DESIGNED: PJB
REVISIONS: No.
DRAWN: DDP
CHECKED: KGF
DATE: 02/05/2014
BY: DESCRIPTION:
ADDENDUM #1

GOLDBECK TOWERS
721 S 1ST AVENUE
HASTINGS, NE 68901

ENLARGED UNIT FLOOR PLANS

SHEET TITLE: ADDENDUM #1

SHEET TITLE: 4TH FLOOR EXISTING FURNACE CLOSET - DEMOLITION

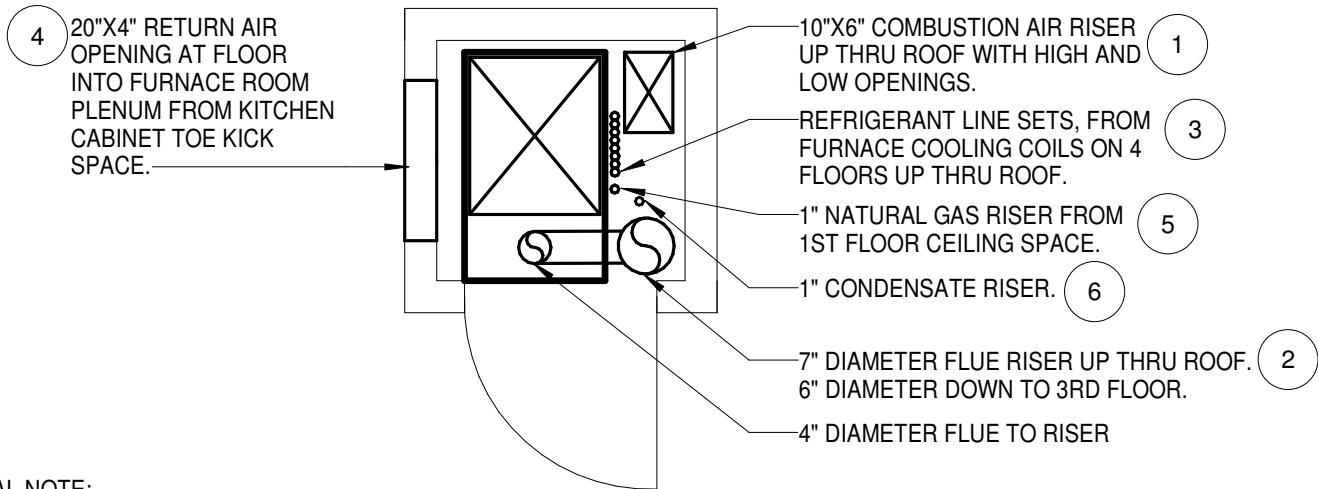
A. WITH PHASING THIS PROJECT FLOOR BY FLOOR AND STARTING ON THE TOP FLOOR, THIS DETAIL NOTES THE MECHANICAL INFRASTRUCTURE THAT NEEDS TO REMAIN AND TO BE COORDINATED IN THE STACKED FURNACE CLOSETS FOR FURNACES ON OTHER FLOORS TO REMAIN OPERATIONAL DURING CONSTRUCTION. THIS DOES NOT REPRESENT A TYPICAL FURNACE CLOSET ONLY TYPICAL COMPONENTS. CLOSET PLAN MAY BE MIRRORED FROM PLAN SHOWN. FIELD VERIFY LAYOUT OF EACH FURNACE CLOSET. 4TH FLOOR CLOSETS ARE TIGHTER ON SPACE THAN LOWER FLOORS, DUE TO LARGER COMBUSTION AIR DUCT AND REFRIGERANT LINE SETS FOR ALL 4 FLOORS Routed THRU CLOSET TO ROOF.

1. COMBUSTION AIR RISER SHALL REMAIN TO SERVE FURNACES ON LOWER FLOORS. PATCH HIGH AND LOW OPENINGS AIRTIGHT IN RISER ON FLOOR WHERE CONSTRUCTION IS TAKING PLACE TO PREVENT CONSTRUCTION DEBRIS AND DUST FROM ENTERING DUCT. COMBUSTION AIR RISER SHALL BE ABANDONED IN PLACE. ACCORDING TO EXISTING DOCUMENTS THERE ARE EXISTING FIRE DAMPERS AT EACH FLOOR PENETRATION. PATCH ROOF OPENING WATERTIGHT AND PATCH ANY FLOOR OPENINGS TO MATCH EXISTING. SEE ARCHITECTURAL PLANS FOR PATCHING REQUIREMENTS.

2. COMMON FLUE RISER SHALL REMAIN TO SERVE FURNACES ON LOWER FLOORS. PATCH 4" DIAMETER OPENING IN RISER WHEN FURNACE IS REMOVED. WHEN CONSTRUCTION ON ALL FLOORS IS COMPLETED, FLUE RISER SHALL BE COMPLETELY REMOVED. PATCH ROOF OPENING WATERTIGHT AND PATCH FLOOR OPENINGS TO MATCH EXISTING. SEE ARCHITECTURAL PLANS FOR PATCHING REQUIREMENTS. IF NECESSARY, TEMPORARILY REMOVE AND REINSTALL A SECTION OF EXISTING FLUE TO REMOVE OR INSTALL FURNACE IN CLOSET. COORDINATE INTERRUPTION IN FURNACE OPERATIONS ON LOWER FLOORS WITH OWNER PROVIDING REQUIRED NOTICE.

3. REFRIGERANT LINE SETS SERVING FURNACE COOLING COILS ON LOWER FLOORS SHALL REMAIN. CORRESPONDING REFRIGERANT LINE SET UP THRU ROOF SHALL BE REMOVED AS FURNACE, ASSOCIATED COOLING COIL AND ASSOCIATED CONDENSING UNIT ON ROOF ARE REMOVED. REUSE EXISTING OPENINGS THRU FLOOR(S) IF POSSIBLE TO RUN NEW REFRIGERANT LINE SETS. PATCH ANY UNUSED OPENINGS.

4. REUSE EXISTING RETURN AIR WALL OPENING FOR DUCTED RETURN AIR IF POSSIBLE. PATCH ANY UNUSED OPENING TO MATCH EXISTING. SEE ARCHITECTURAL PLANS FOR PATCHING REQUIREMENTS.

5. GAS RISER LOCATION SHOWN IS APPROXIMATE AND MAY NOT BE CONSISTENT IN ALL FURNACE CLOSETS. FIELD VERIFY GAS RISER LOCATION. IF NECESSARY FOR FURNACE REMOVAL, DISCONNECT AND RELOCATE GAS RISER OR BRANCH PIPING. GAS RISER SERVES FURNACES ON ALL FOUR FLOORS. FURNACES ON OTHER FLOORS SHALL REMAIN OPERATIONAL DURING CONSTRUCTION. PLAN AND COORDINATE ANY INTERRUPTION IN NATURAL GAS SERVICE WITHIN REQUIRED TIME FRAME WITH OWNER.

6. CONDENSATE RISER LOCATION SHOWN IS APPROXIMATE AND MAY NOT BE CONSISTENT IN ALL FURNACE CLOSETS. FIELD VERIFY LOCATION. CONDENSATE RISER SHALL REMAIN FUNCTIONAL FOR FURNACES ON OTHER FLOORS DURING CONSTRUCTION. COORDINATE ANY MODIFICATIONS OR INTERRUPTIONS TO CONDENSATE ROUTING THAT AFFECTS OTHER FLOORS WITH OWNER WITHIN REQUIRED TIME FRAME.

4TH FLOOR FURNACE CLOSET - REMODELED

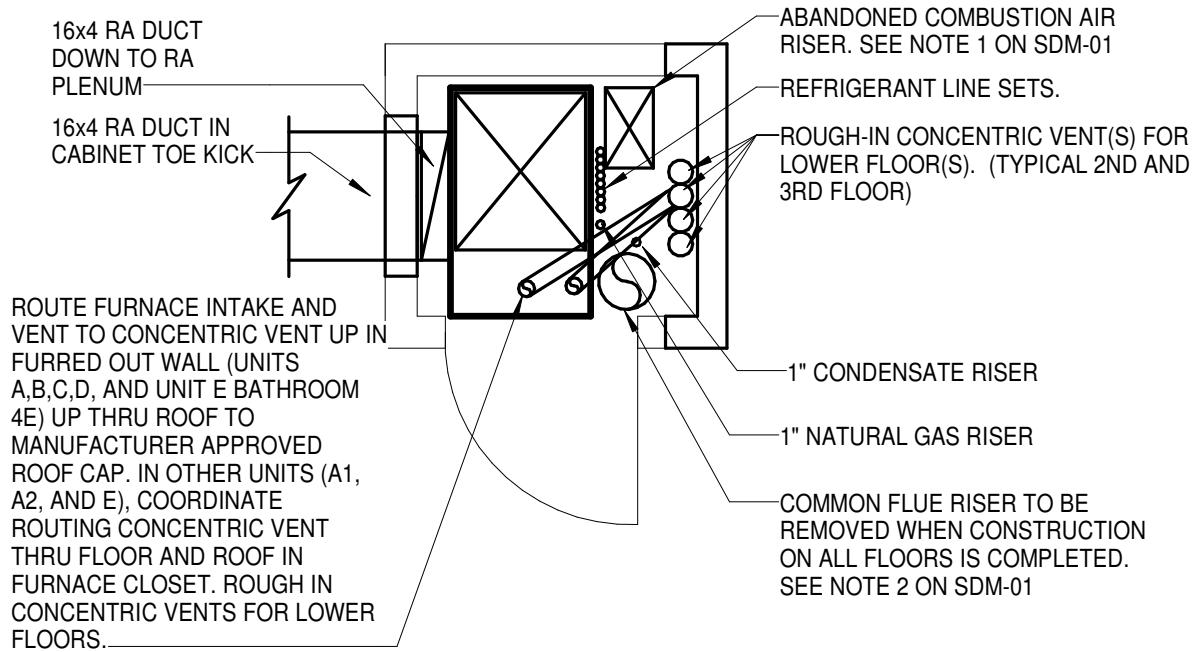
- A. THIS DETAIL DOES NOT REPRESENT A TYPICAL FURNACE CLOSET, ONLY TYPICAL MECHANICAL COMPONENTS. FIELD VERIFY LAYOUT OF EACH FURNACE CLOSET. 4TH FLOOR CLOSETS ARE TYPICALLY TIGHTER ON SPACE THAN LOWER FLOORS DUE TO EXISTING COMBUSTION AIR DUCT, REFRIGERANT LINE SETS FOR 4 FURNACE SYSTEMS ON 4 FLOORS, AND VENTING FOR 4 FURNACES. MODIFICATIONS TO EXISTING ITEMS IN FURNACE CLOSETS MAYBE NECESSARY FOR INSTALLATION OF FURNACE SYSTEMS WITH PHASING OF PROJECT. COORDINATE ANY INTERRUPTION TO FURNACE SYSTEM OPERATIONS ON OTHER FLOORS WITH OWNER.

1 UNIT D - LIGHTING
SCALE: 1/4" = 1'-0"

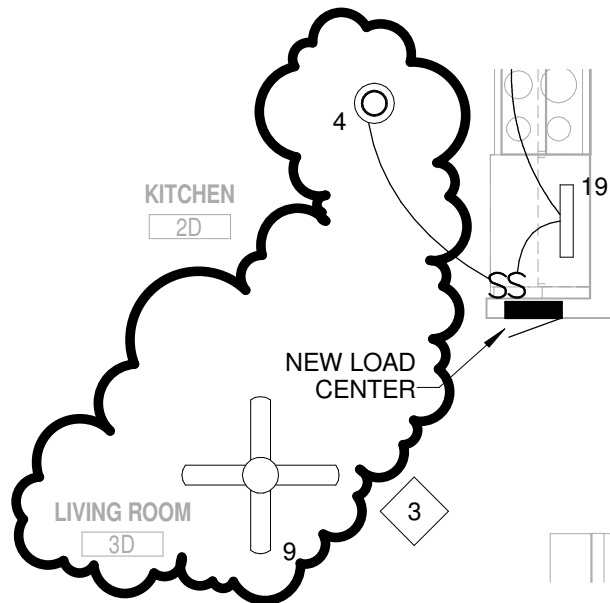
1. UNLESS OTHERWISE NOTED, INSTALL LIGHTING IN PLACE OF LUMINAIRES REMOVED IN DEMOLITION, AND CONNECT TO CIRCUIT PREVIOUSLY SERVING LIGHTING.
2. PROVIDE NEW SWITCH IN EXISTING WALL AND CONNECT TO LIGHT INDICATED.
3. CONNECT LIGHTING TO CIRCUIT 1 IN NEW LOAD CENTER, TYPICAL ENTIRE UNIT. VERIFY LOCATION OF LUMINAIRES WITH OWNER PRIOR TO ROUGH-IN.
4. CONNECT NEW LUMINAIRES TO LIGHTING CIRCUIT SERVING UNIT. VERIFY LOCATION OF LUMINAIRES WITH OWNER PRIOR TO ROUGH-IN.
